Proposal for Amendment 1 to UN Global Technical Regulation No. 13, Phase 2 (Hydrogen and Fuel Cell Vehicles)

Submitted by the Working Party on Passive Safety *

The text reproduced below was recommended by the Working Party on Passive Safety (GRSP) at its seventy-second session (ECE/TRANS/WP.29/GRSP/72, para. 8). It is based on ECE/TRANS/WP.29/GRSP/2022/16 as amended by annex II to the report). It is submitted to the World Forum for Harmonization of Vehicle Regulations (WP.29) and to the Executive Committee (AC.3) of the 1998 Agreement for consideration at their June 2023 sessions.

Figure 6

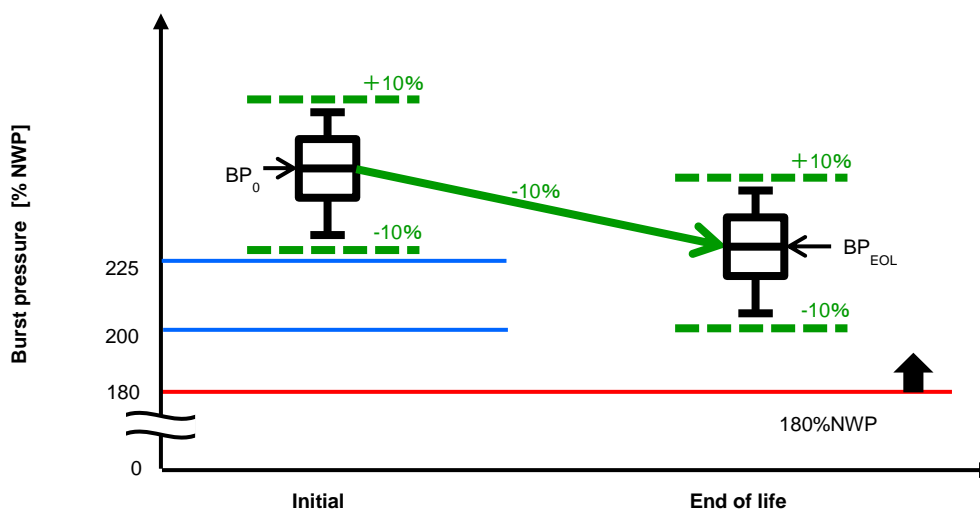
65. In subsequent discussions of Phase 2, Japan presented data from experiments using carbon-fibre composite containers for 70 MPa, to support the minimum initial burst pressure change from 225 per cent NWP to 200 per cent NWP for carbon fibre containers only (Tomioka, J. et al. (2019 September); "Influences of Hydraulic Sequential Tests on the Burst Strength of Type-4 Compressed Hydrogen Containers." 2019 International Conference on Hydrogen Safety. Technical Paper ID 159).

66. The relationship between the current initial burst pressure requirement and the estimated end-of-life burst pressure requirement is shown in Figure 6. The Japanese experiment showed that containers which met the $BP_0 \pm 10$ per cent requirement and subjected to the hydraulic sequential tests, were able to meet end-of-life burst pressure of at least 180 per cent NWP, even if the minimum initial burst pressure is reduced to 200 per cent NWP.

Figure 7
Results from the Verification Test

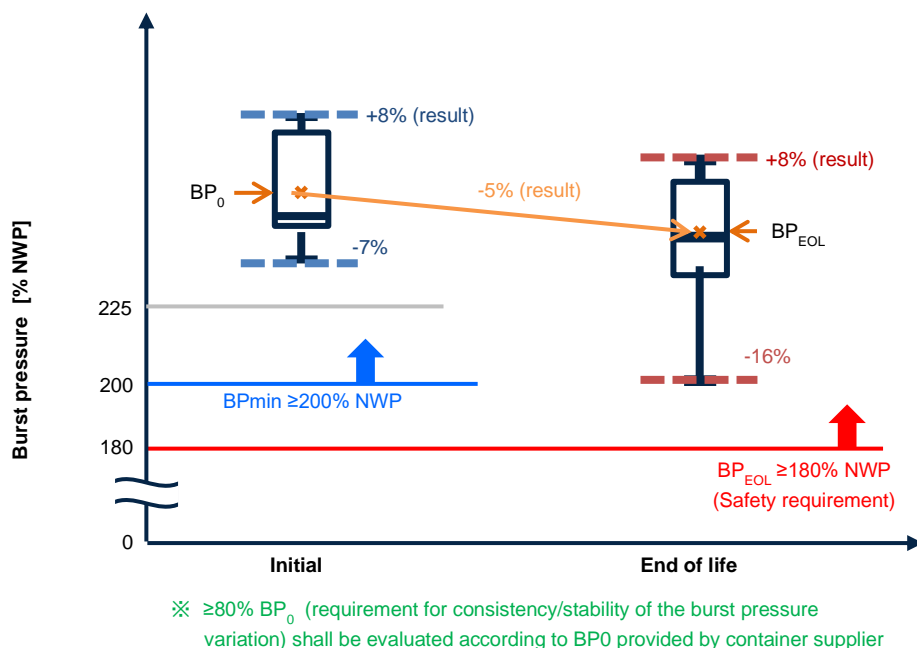
68. The test results are shown in Figure 7. The minimum value of the initial burst pressure was greater than 225 per cent, and within the ± 10 per cent of BP_0 requirement. The end-of-life burst pressure, which takes into account the variation and degradation ratio due to testing, was greater than 180 per cent NWP. It was also greater than 80 per cent of BP_0 by a sufficient margin (Figure 8).

69. The results show that the minimum initial burst pressure of 225 per cent NWP can be reduced to 200 per cent NWP while maintaining end-of-life burst pressure (BP_{EOL}) above 180 per cent NWP and 80 per cent of BP_0 requirements.
